Model: All Labrie, Wittke, Pendpac

Subject: New Mac Valve

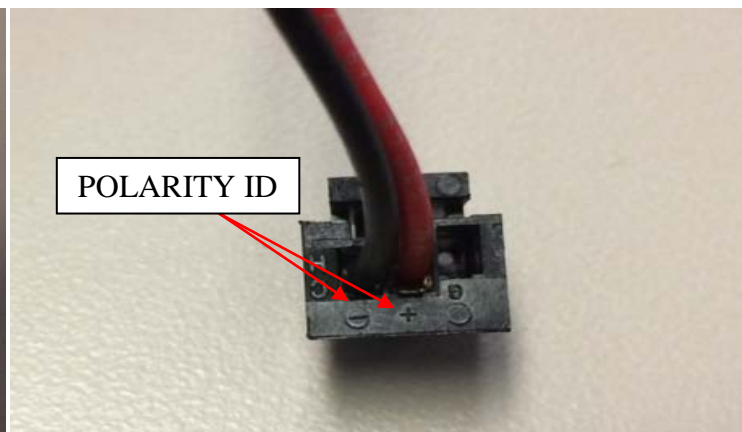
A new type of Mac pneumatic control valve has been introduced into the Labrie and Wittke product lines. The current production Mac valve, part number PNV01965-01, may be identified by its red & black wire leads, with a white connector. The PNV01965-01 Mac valve replaces the PNV01965 and S16-0548 Mac valves.

The PNV01965-01 Mac valve is equipped with a circuit protection diode, whereas the previous production Mac valves did not have diode protection. The current production Mac valve may be used as a substitute for the previous production Mac valve provided the polarity of the new Mac valve is correctly observed during installation. The red wire must be connected to the positive (+) power source, and the black wire must be connected to the ground (-). Polarity is also marked on the wire connector at the Mac valve for reference.
